Response to Request for Additional Information – ANP-10268P
“U.S. EPR Severe Accident Evaluation Topical Report” (TAC No. MD3803)

Figure RAI-6-1 Reactor Cavity Corium Temperature Response

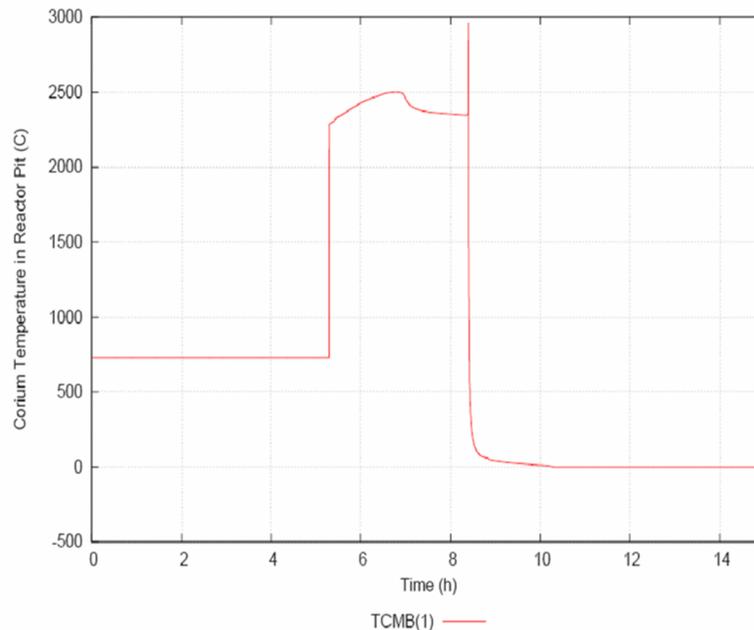
It is stated that the high iron oxide content of the reactor cavity concrete promotes oxidation of the remaining zirconium and uranium within the melt, before the zirconium bricks would be attacked. How high does the melt temperature increase from this oxidation, and why doesn't this temperature increase lead to a higher melt temperature for spreading?

While the oxidation of metals within the core melt will add energy to the mixture, a significant amount of energy is lost through the decomposition of concrete and, to a lesser extent, thermal radiation to the reactor cavity environment. Calculation results show that there is a small difference in melt temperature between the time of reactor vessel failure and gate failure; however, the effects of the different heat transfer mechanisms do appear in between those times. Since the resident metals within the core melt oxidize at a rate proportional to the supply of concrete decomposition products, the impact on corium temperature is visible during the early portion of the retention phase. As the Zr and U metals are depleted, the dominant concrete decomposition products (iron oxide and silica) start to accumulate in the melt, lower the liquidus temperature and consequently, the melt temperature. Additional contributors to the temperature decrease are the heat loss due to concrete decomposition and thermal radiation. As shown in Figure RAI-6-1 (a revised calculation result for the SBLOCA case provided in the topical), the contributions of these primary heat transfer mechanisms appear to essentially offset one another. Specifically, Figure RAI-6-1—Reactor Cavity Corium Temperature Response, illustrates the temperature response of the corium in the reactor cavity.

Note: the temperature spike at the time of gate failure is the result of a numerical anomaly and has no physical basis.

Figure RAI-40-1 MAAP4.0.7 Predicted Average Melt Temperature vs. CCI-2 Data (Basemat Only)

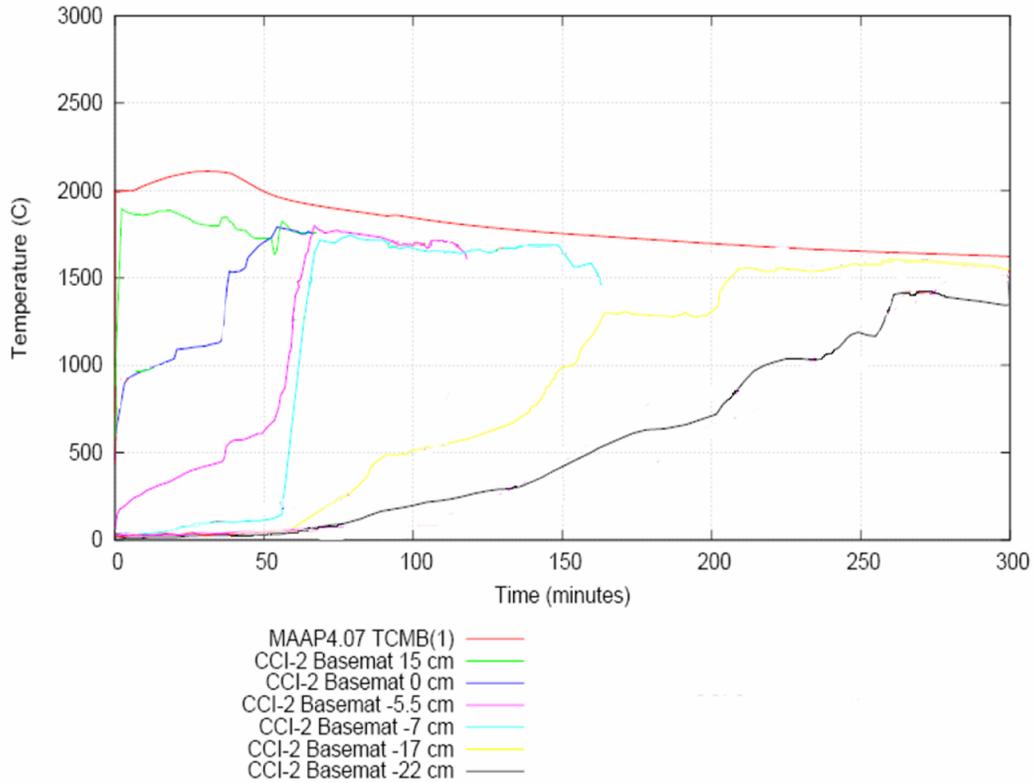
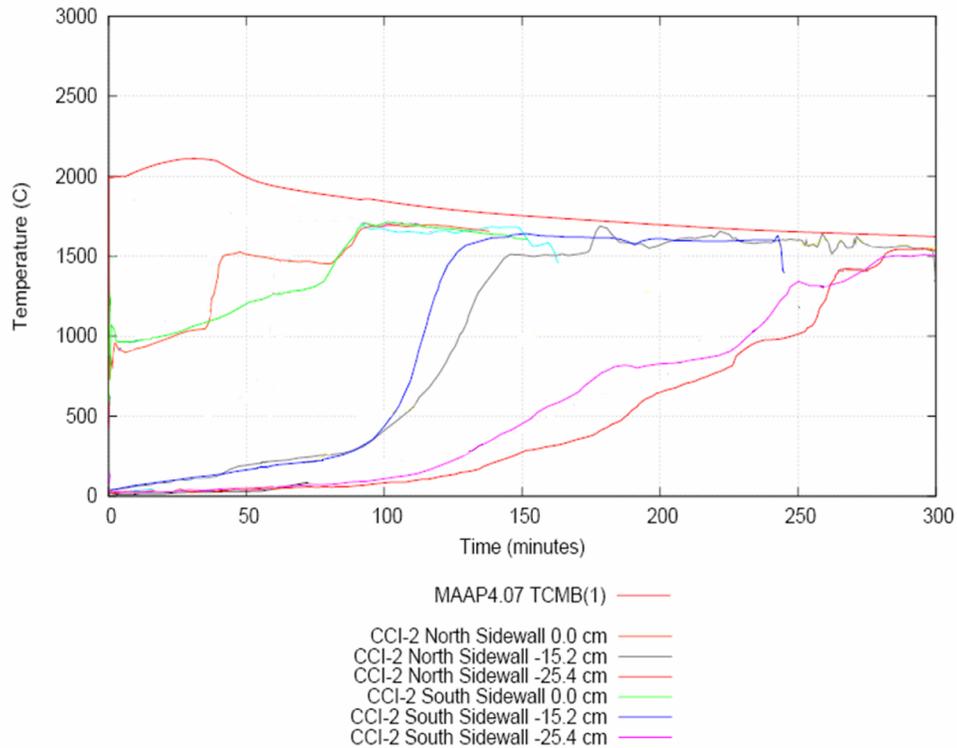
It is not clear which curve represents the MAAP 4.0.7 results. There are several red curves shown. Please provide a more clear delineation of the various curves.

Following are two graphs which delineate the data in Figure 6-14 between the basemat and the sidewall:

Figure RAI-46-1 MAAP4 – Primary System Water Nodes

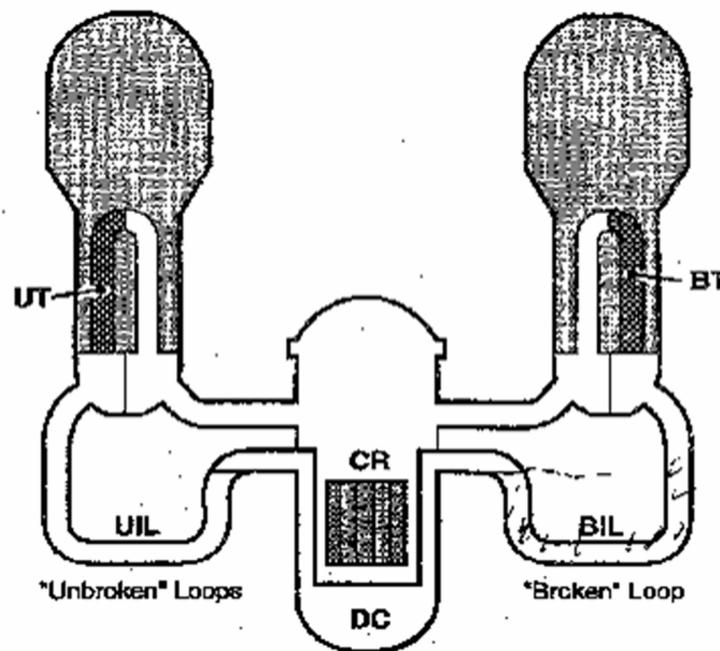
- b) Following lower plenum dryout at 2 hours (Figure 7-8), there is still about 20 tons of water in the RCS. Where is this water coming from?

The additional water after lower plenum dryout is trapped in the unbroken loop intermediate leg (UIL) and broken loop intermediate leg (BIL). The location of the MAAP nodes UIL and BIL are shown in Figure RAI-46-1.
